167 Fore Street – Ocean Gateway Garage Addition

April 23, 2019

Amendment

Level II Site Plan Application

Title
SITE PLAN

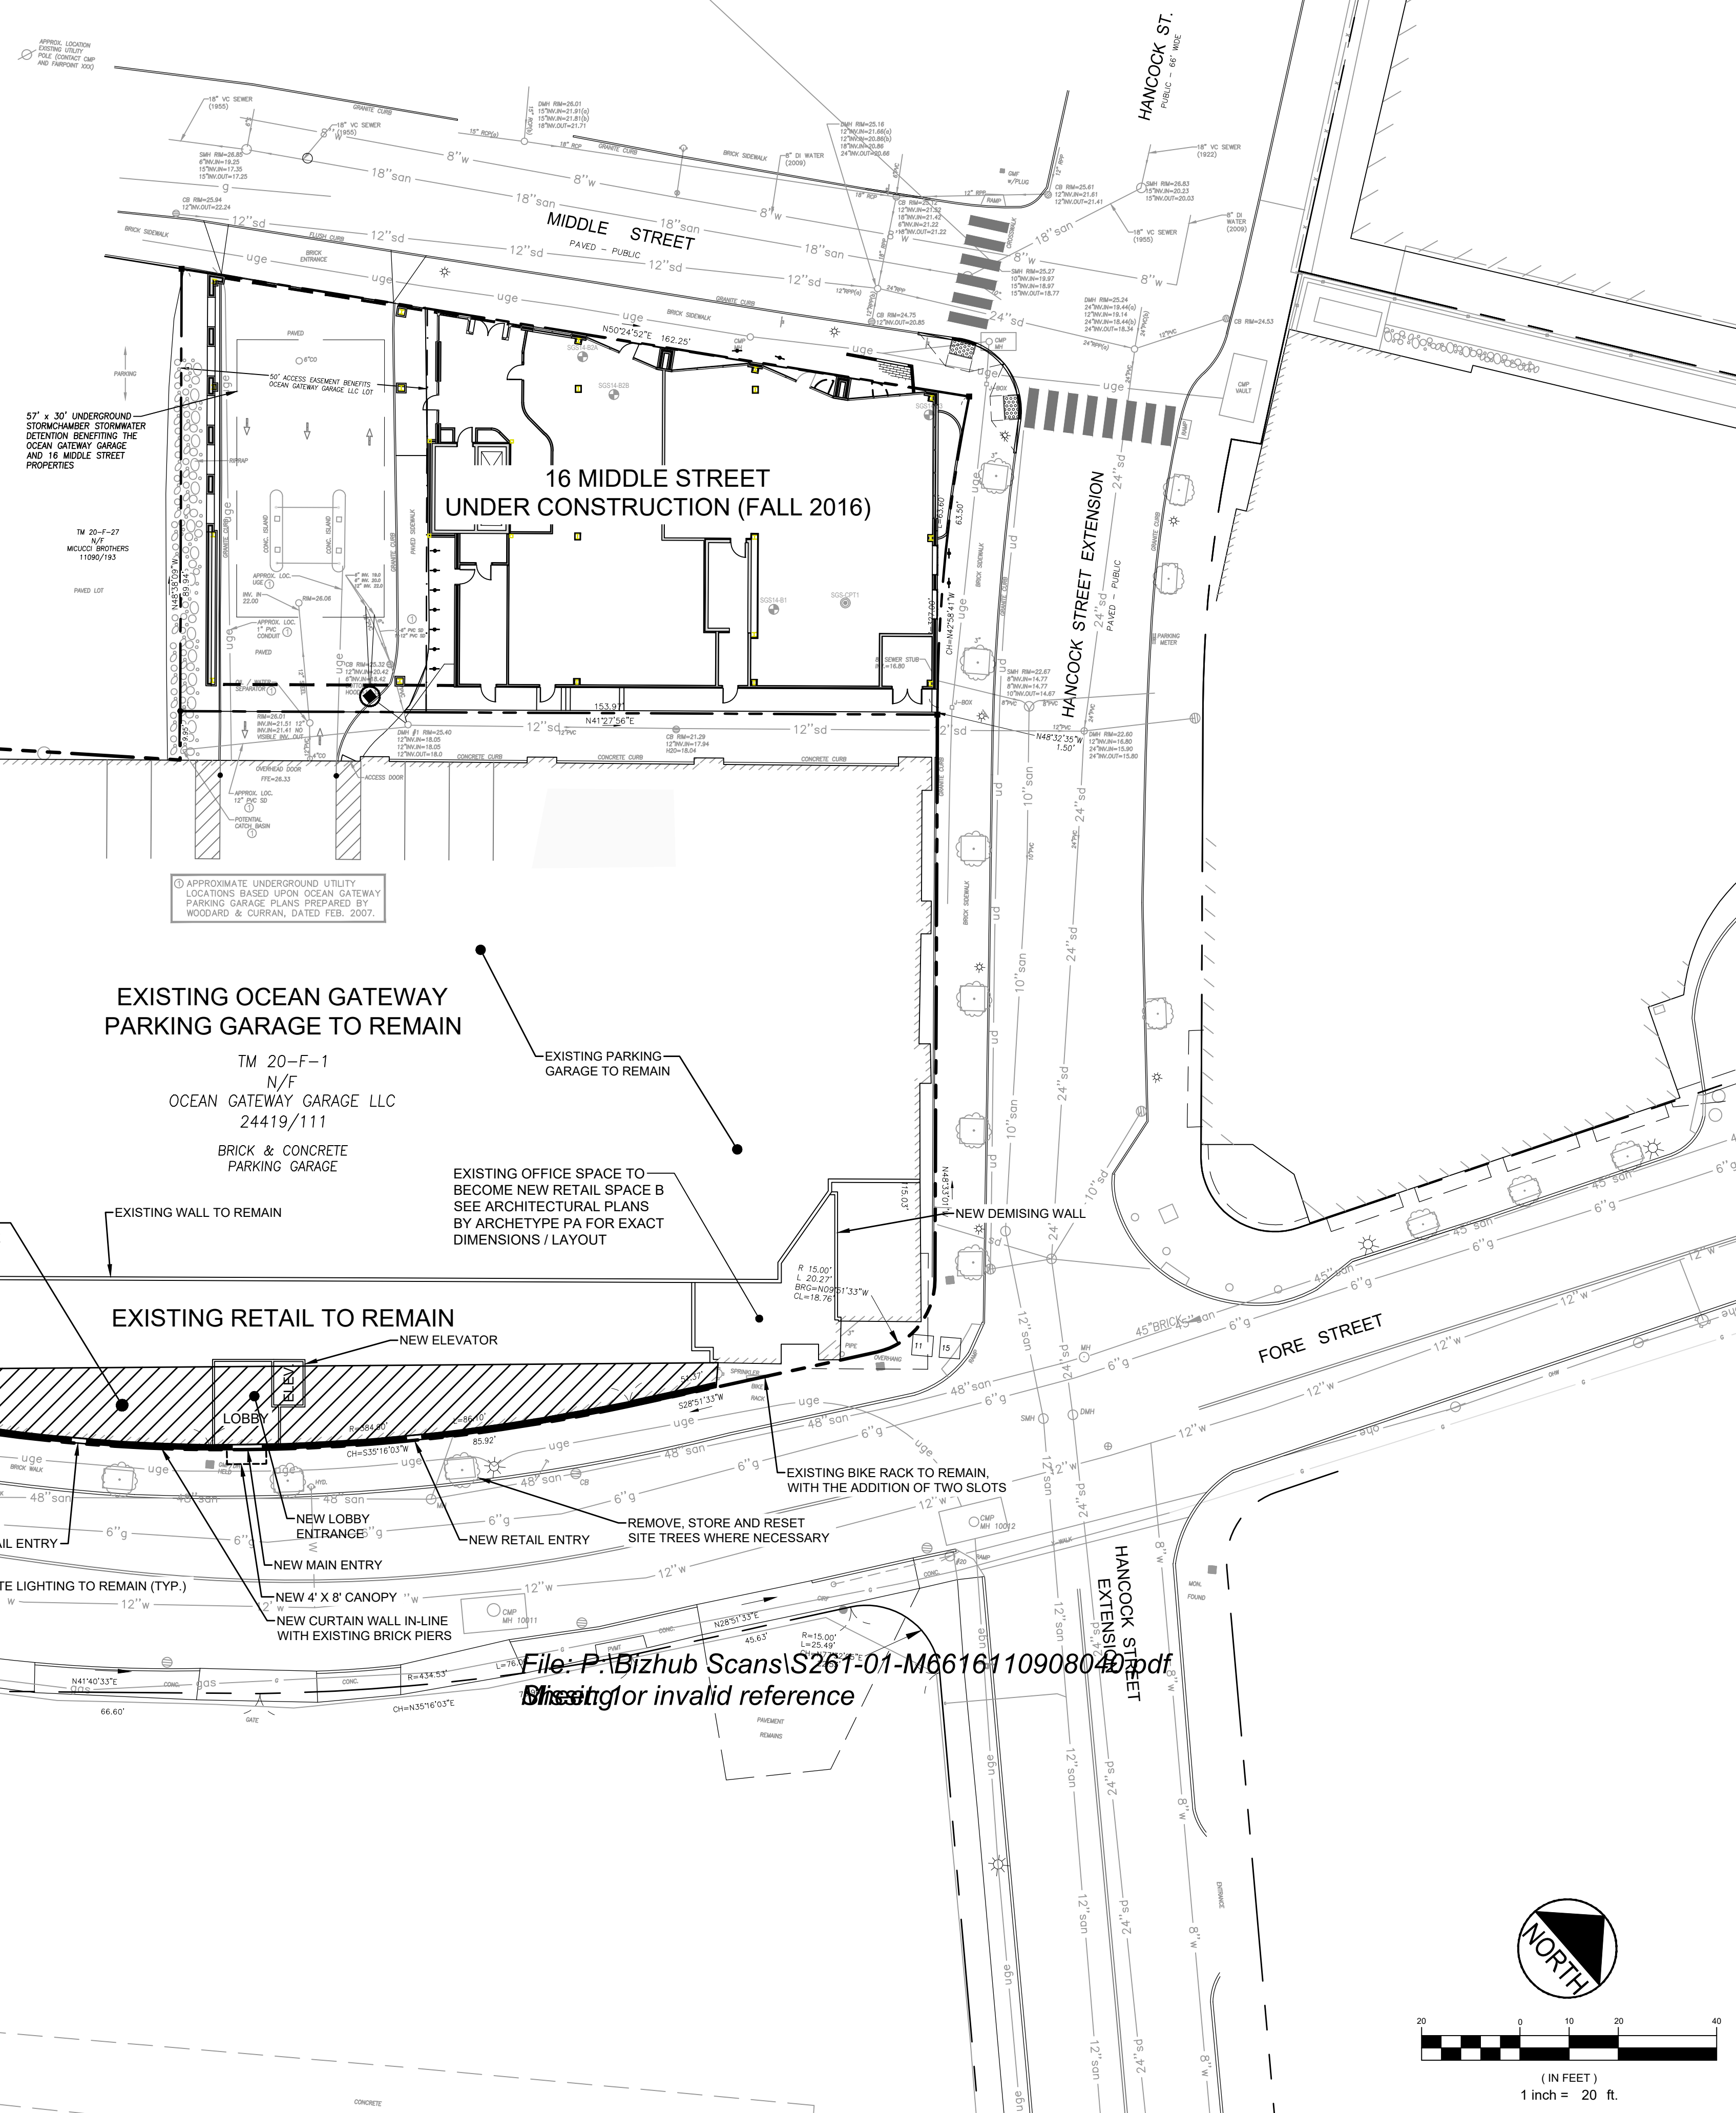
The attached plans (revised site plan and mechanical plans) demonstrate the amendment to the HVAC design as part of the original Level II Site Plan application for the Ocean Gateway Garage Addition at 167 Fore Street.

The original design intent was for the HVAC units to be located within a parking spot, typical of each level. Due to site constraints and parking requirements/lease agreements filed with the city, the location of these HVAC units was revised and resubmitted. The locations shown on the attached drawings represent the only feasible location within the existing garage layout, and all units are kept internal to the garage structure, not visible to the surrounding neighborhood.
